Access Compliance Report

Public Rights-of-Way

(Curb Ramps)

Intersection ID: 10014712	Main Street: NORLAND_RD	Cross Street: N/A	Location: W
ADA ID: 2096DA1C8BD3	Ramp Type: PerpDiag	Initial Pass/Fail: Fail	Overall Compliance: No
Severity Score: 25			
Codes/Mitigation Info/Possible Solution		Field Measurements/Component Compliance

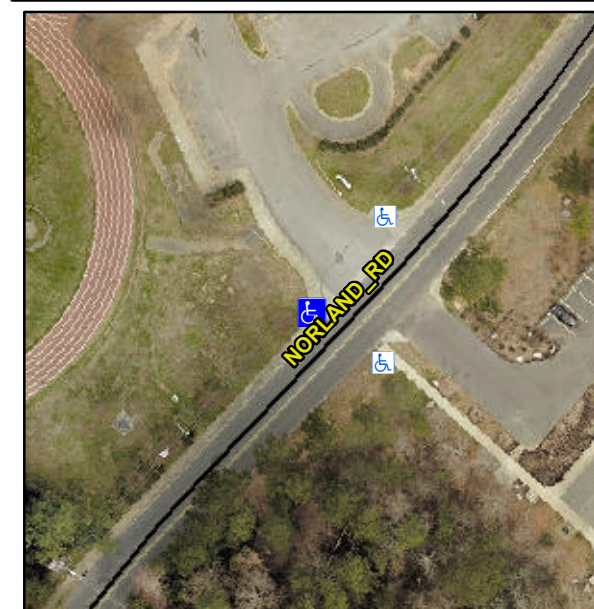
R304.2.2, R304.5.3

Compliance	Description	Data	Compliance	Description	Data
N/A	Ramp Length (in)	73.5	No	Ramp Slope (%)	9.1
Yes	Ramp Width (in)	54.0	No	Ramp XSlope (%)	5.3
N/A	Flare Type LT	N/A	N/A	Flare Type RT	N/A
N/A	Flare Slope LT (%)	N/A	N/A	Flare Slope RT (%)	N/A
N/A	Flare Traversable LT?	N/A	N/A	Flare Traversable RT?	N/A
N/A	Landing Length (in)	N/A	N/A	DWS Provided?	N/A
N/A	Landing Width (in)	N/A	N/A	DWS Contrast?	N/A
N/A	Landing Slope (%)	N/A	N/A	DWS Length (in)	N/A
N/A	Landing X Slope (%)	N/A	N/A	DWS Full Width?	N/A
N/A	Landing Curb? (Y/N)	N/A	N/A	DWS Offset (in)	N/A
N/A	Shared Landing?	N/A			
N/A	Gutter Ponding?	N/A	N/A	Gutter Slope (%)	N/A
N/A	Gutter Lip Ht (in)	N/A	N/A	Gutter X Slope (%)	N/A
N/A	Painted X Walk1?	No	N/A	Painted X Walk2?	No
	X Walk 1 Direction	To SE		X Walk 2 Direction	To NE
N/A	X Walk 1 Width (in)	N/A	N/A	X Walk 2 Width (in)	N/A
	X Walk 1 Slope (%)	0.8		X Walk 2 Slope (%)	2.2
	X Walk 1 X Slope (%)	1.3		X Walk 2 X Slope (%)	1.3

Remove & Replace Curb Ramp With Two New Directional Ramps or Equivalent.
